**Amendments to the Drawings**

**Please consider the attached proposed replacement drawing sheet 2.**

FIG. 2

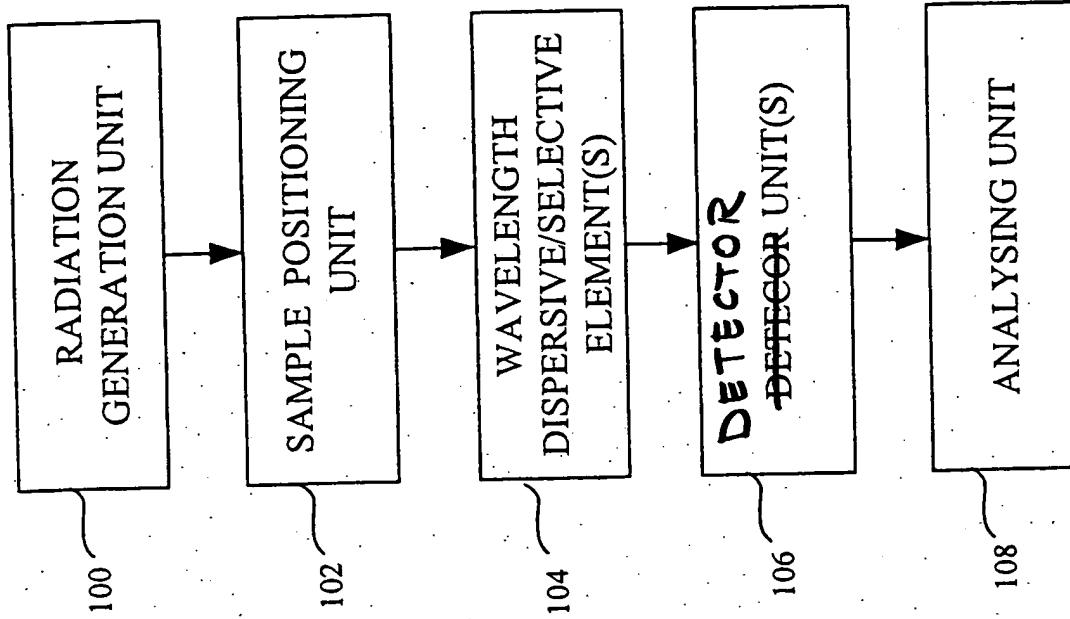
The attached sheet of drawings, comprising Figures 1b and 2, is presented as a proposed replacement sheet for drawing sheet 2 as originally filed. This sheet includes a proposed amendment to Figure 2. In Figure 2, the spelling of the word "DETECOR" has been corrected to read "DETECTOR". Support for the correction is provided by the specification at page 9, lines 4-5.
